UNITED STATES PATENT AND TRADEMARK OFFICE

10/667,115

Office Action Summary

DETAILED ACTION

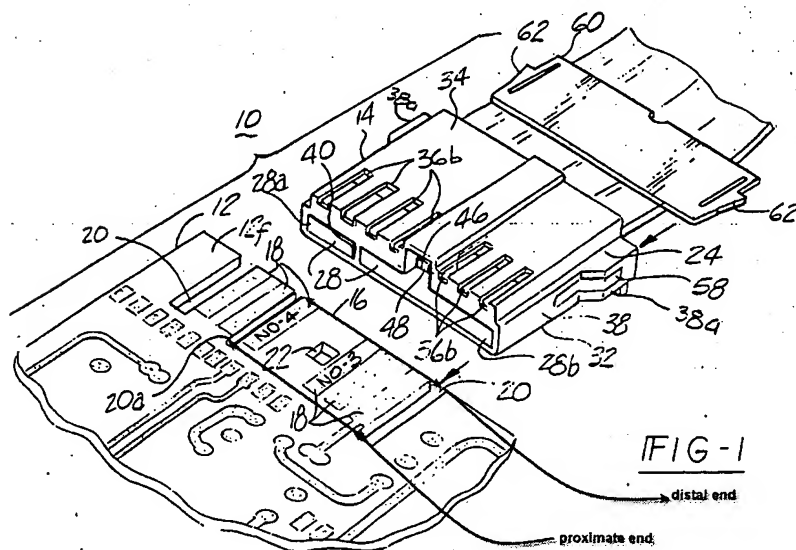
As to claims 1-3, Matson discloses a circuit board (12, column 2, line 7) as shown in figures 1-2 comprising: a mechanism (16, column 2, line 9) comprising:

signal means for (wire traces 18, and circuitries formed in/on the circuit board 12)
conducting a signal between the mechanism (16) and the circuit board (12); and

separation means (gaps 20, column 2, line 15) for facilitating detachment of the
mechanism (16) from the circuit board (12);

identification means for (labels No.1-No.6, figure 1 shows the label No.3 and
No.4) identifying the mechanism (16);

wherein the circuit board becomes at least partly non-functional if the mechanism
is detached from the circuit board.

As best understood to claims 34, 40-41, Matson discloses a circuit board
assembly, shown in figure 1 comprising: a circuit board (12) comprising a tab (key tab-

16) having: proximate and distal ends (see figure above); and two opposing sides separated from the assembly by gaps (slots 20); an identification (labels NO.1-No.6 formed on conductor runs 18 to identify the function of leads/pins of the conductor runs) situated on the tab (16); and a signal conductor (traces or wirings on the board) extending from the circuit board to the tab and configured to convey a signal when the assembly is powered.

As to claim 42, Matson discloses the signal conductor (traces) does not extend to the distal end of the tab (16).
